Jersey Central Power & Light Company  
ATTN: Mr. I. R. Finfrock, Jr.  
Vice President - Generation  
Madison Avenue at Punch Bowl Road  
Morristown, New Jersey 07960

Change No. 18  
License No. DPR-16

CHANGE NO. 18 TO TECHNICAL SPECIFICATIONS

DOCKET NO. 50-219

FIGURE 3.10.1

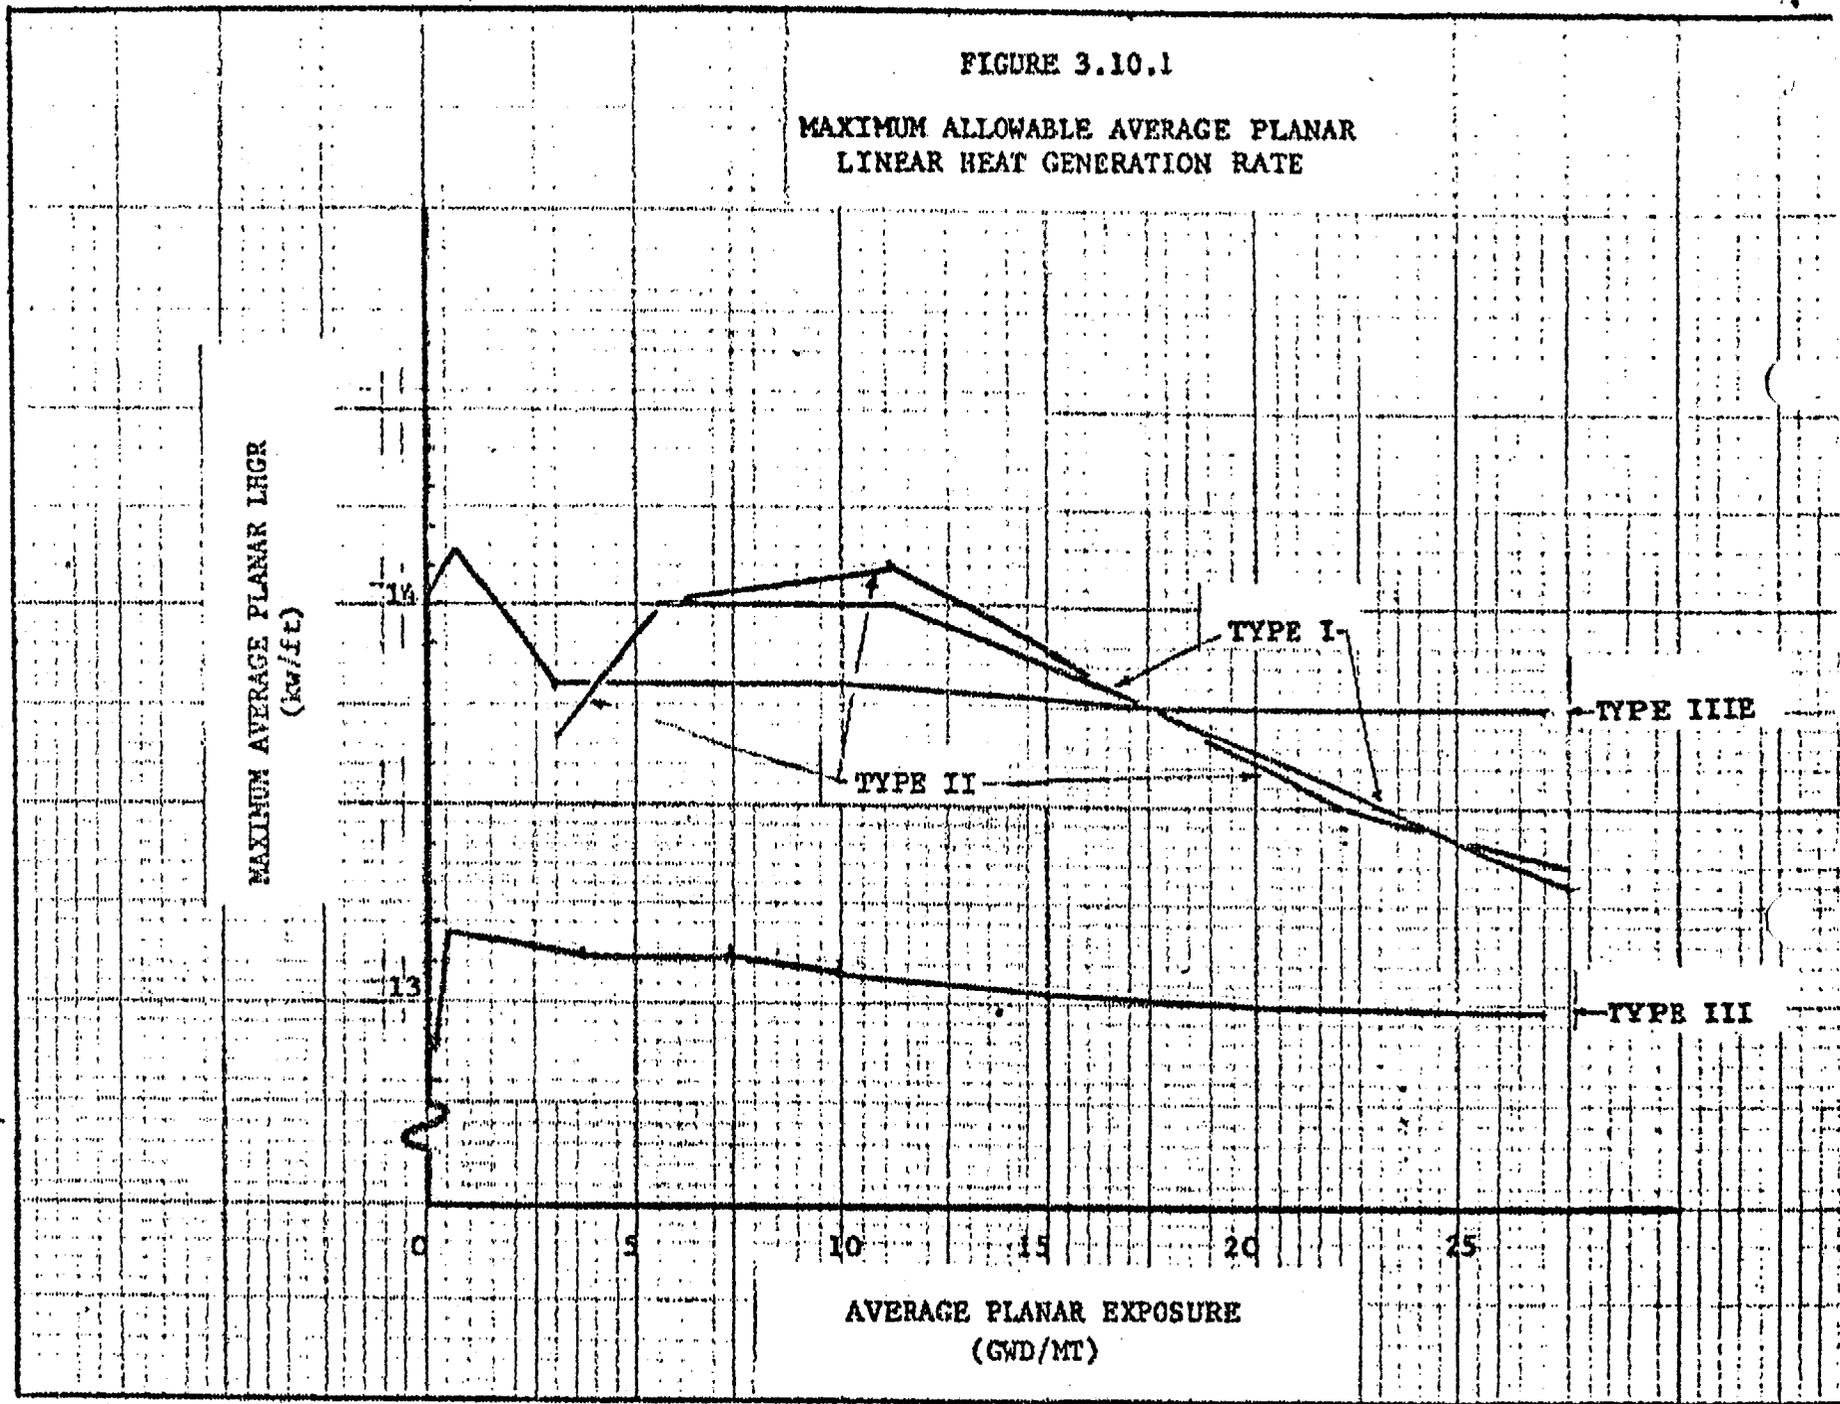
Your letter dated December 14, 1973, proposed changes to the Technical Specifications of Facility License No. DPR-16 for the Oyster Creek reactor that would increase the maximum average planar linear heat generation rate (MAPLHGR). These changes in the MAPLHGR are the result of changes in the fuel densification model by the General Electric Company as reported in NEDO-20181, "GEGAP III A Model for Prediction of Pellet-Clad Thermal Conductance in BWR Fuel Rods", dated November 1973 and its supplement NEDC-20181 Supplement 1 (Proprietary) dated November 1973 and by EXXON Nuclear as reported in XN-174, "Technical Report on Densification of EXXON Nuclear BWR Fuel", dated November 1973. Modifications to the proposed models were made by the Regulatory staff and transmitted by our letters to you dated December 5 and December 13, 1973, respectively.

1. Replace Figure 3.10.1 on page 3.10-4, Change No. 17, with the attached Figure 3.10-1, page 3.10-4, Change No. 18.
2. Replace Bases, pages 3.10-2 and 3.10-3, Changes No. 16 and 17, with the attached pages 3.10-2 and 3.10-3, Change No. 18.

The maximum average planar LHGR shown in Figure 3.10.1 for Type I and II fuel is the result of LOCA analyses using values of gap conductance calculated per GEGAP III (G.E. Topical Report, NEDO-20181, "A Model for the Prediction of Pellet Cladding Thermal Conductance in BWR Fuel Rods") with AEC modifications ("Modified G.E. Model for Fuel Densification", December 5, 1973). The Type I curve is the same as the curve labeled "Ω" (Omega) on Figure 5-A of a report attached to a letter dated December 12, 1973, to the AEC from General Electric Company. The Type II curve is the same as the curve labeled "Ω" (Omega) on Figure 6-A of the same report. These calculations were made to determine the effect of densification on PCT following a postulated LOCA and include the results of detailed heatup calculations for the PCT at exposures up to 25,000 MWD/MT.

The maximum average planar LHGR shown in Figure 3.10.1 for Type III and IIIIE fuel are the result of calculations presented in Supplement No. 1 to the Exxon Nuclear Company Topical Report, XN-174, "Densification Effects on Nuclear Boiling Water Reactor Fuel", December 1973. These calculations were made to determine the effect of fuel densification on PCT following a postulated LOCA and include the results of detailed heatup calculations for the PCT to maximum planar exposures of 25,000 MWD/MT.
